CITY OF ROCHESTER, NEW YORK

PORTLAND AVENUE REVITALIZATION

FROM LUX STREET TO NORTON STREET

90% PLANS
APRIL 16, 2014

LUX STREET GATEWAY PLAN
NOT TO SCALE

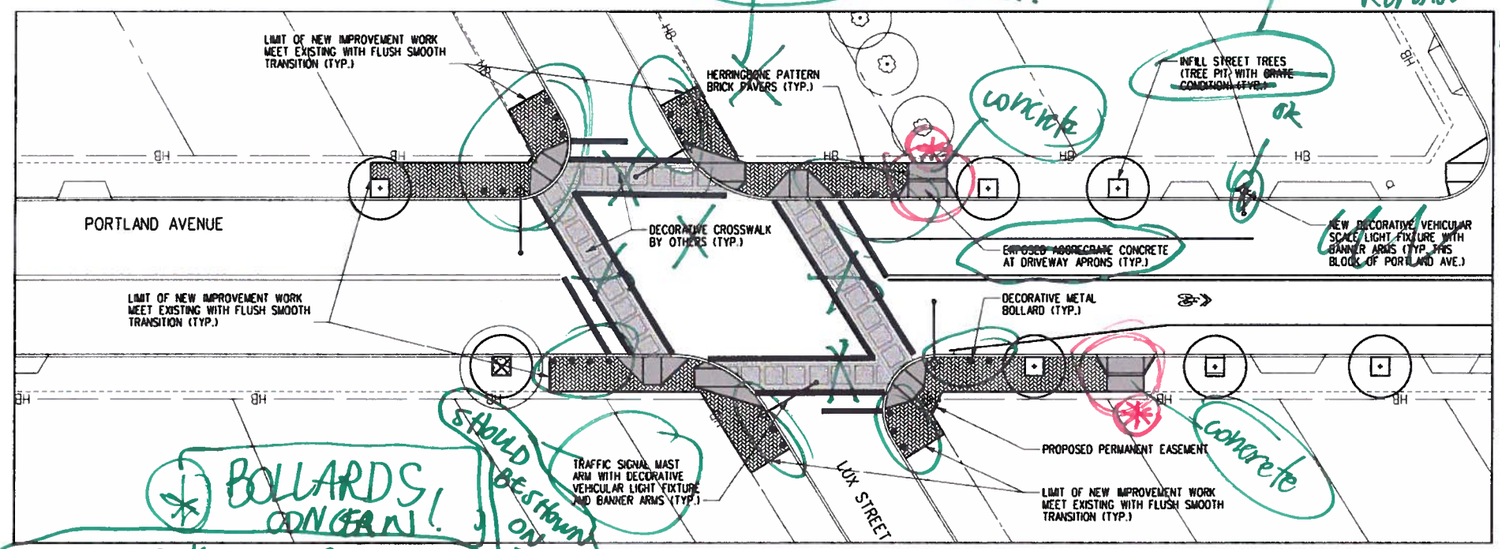
NO GRATES! REPLACE w/ MULCH OR FLEXIPAVE! RETURN GRATES TO CITY

NORTON STREET GATEWAY PLAN
NOT TO SCALE

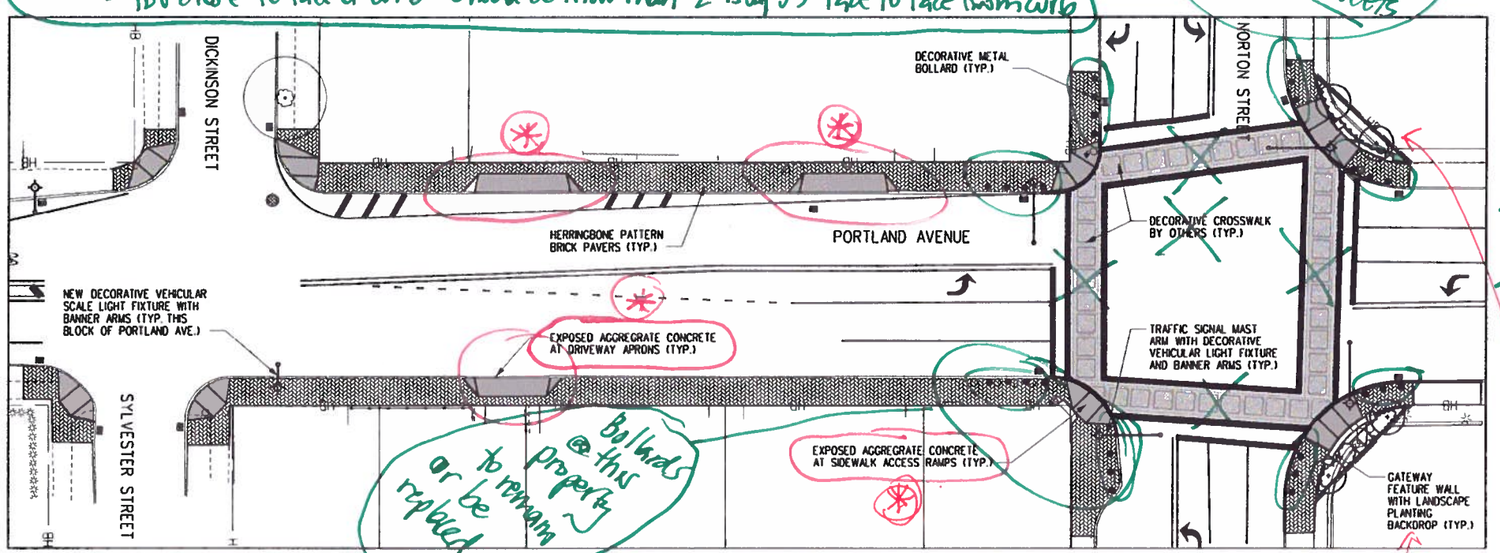
if this is a detail plan then make scale larger so it is visible!!

Bollards @ this property to remain or be replaced
